**From:** [Chavez, Carl, EMNRD](#)  
**To:** [Laura Angell](#)  
**Subject:** RE: [EXTERNAL] Re: BW-37 State "4" BSW No.1 (API# 30-025-26370) Technical Issues Identified Follow-Up  
**Date:** Tuesday, April 25, 2023 11:37:00 AM  
**Attachments:** [Laura A Memo 4-5-2023.pdf](#)

**Discharge Plan Application for Brine Extraction Facilities  
Tatum Brine Station – State 4 BSW #1**

**Closure Plan**

**Financial Assurance Plan**

Well Diagram  
Llano Disposal, LLC  
State '4' BSW #1  
API # 30-025-26370

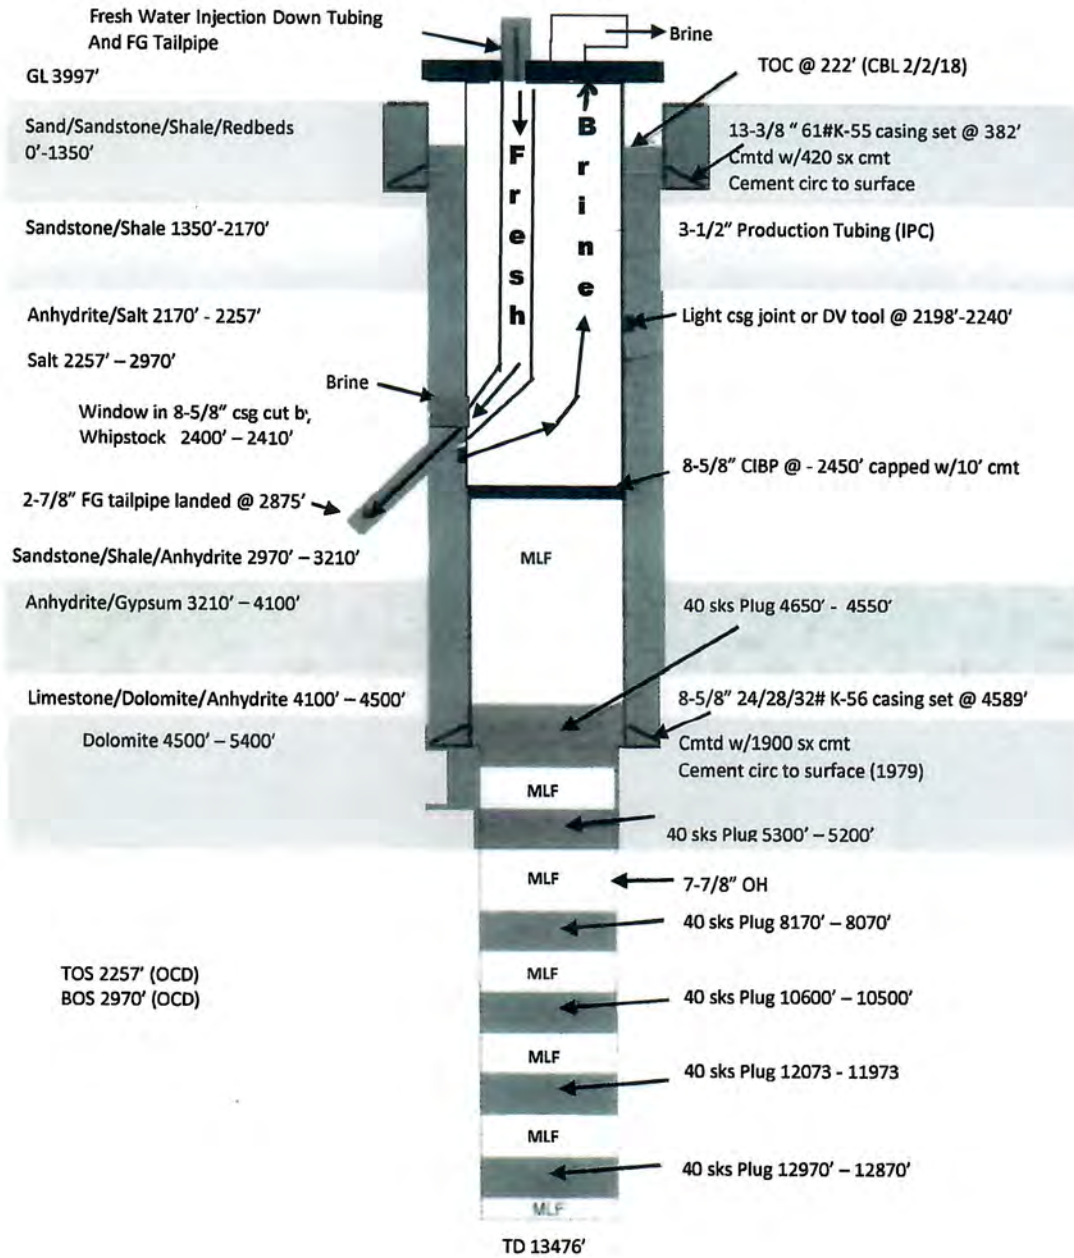
1. Ensure subsidence monuments have been constructed and surveying has been completed.*[Carl says: ] Resolved.*
2. Ensure the well diagram is current.*[Carl says: ] Unresolved.*
3. A map to scale displaying the well, surface facilities and any monitoring wells is requested.*[Carl says: ] Unresolved.*
